M E M O R A N D U M

DATE: October 26, 2001
TO: Montgomery County Planning Board
FROM: A. Malcolm Shaneman
Planning Department
(301) 495-4587
SUBJECT: Informational Maps for Subdivision Items on the
Planning Board's Agenda for November 01, 2001.

REVIEW TYPE: Preliminary Plan Review

APPLYING FOR: Resubdivision of Existing Lot 34 Block J Burnt Mills Village For Two Lots

RESUBDIVISION
Residential Re-subdivision
Block J
Lot 34
Burn Mill Village County, Maryland

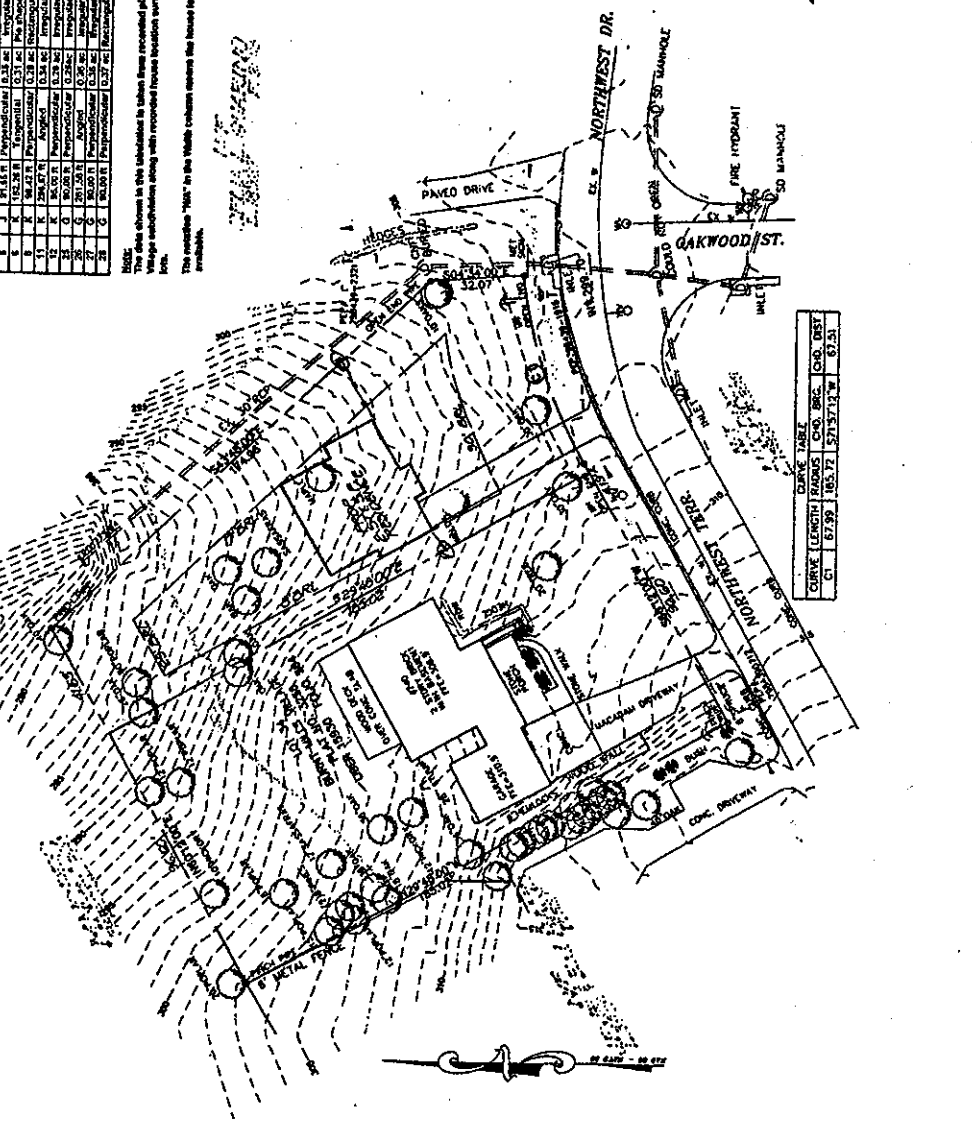
Again, this request is to create two lots that staff has examined for consistency with the subdivision criteria. It is the staff determination that the requested lots will fail the criteria for size, frontage and useable area. Although the 12,229 square foot lot will not be the smallest within the neighborhood, it is well toward the smaller end of the scale. Staff further notes that the smaller lots in the neighborhood have wider frontage than proposed (e.g., lots 2, 3, 4), thus the shape also would be inconsistent with smaller lots with straight road frontage. Only 7 lots would be smaller. Frontage on this lot is 75 feet, and staff notes frontage this narrow exists in the neighborhood only within the lots located on the radial curve of Northwest Terrace (and not on the straight road frontages). Neither of the proposed lots are true radial lots.

Additionally, staff concludes that the area of the smaller proposed lot. Fails to meet the resubdivision criteria. While the smaller proposed lot *could* accommodate a residential unit, the area available for a house location is the smallest within the neighborhood and is inconsistent with the building area within the neighborhood.

The staff review identifies four criteria upon which the resubdivision fails: size, useable area, shape and frontage. It should be reiterated that the Planning Board must find that the proposed resubdivision substantially meets *all* of the resubdivision criteria. Staff based failure of the size and frontage criteria on the fact that the smaller proposed lots is closer to the size of the smallest lots within the neighborhood and would not be representative of the median range. The small lots, with narrow street frontage, also are not consistent with the character of the smaller lots that have wider road frontage, or with the narrower radial lots that include more square footage. It also was staffs' determination that the useable area of the proposed small lot would actually be the least within the defined neighborhood, thereby giving cause for finding failure to meet the resubdivision criteria.

STAFF RECOMMENDATION: Denial, Pursuant to Section 50-29 (b)(2), Montgomery County Subdivision Regulations
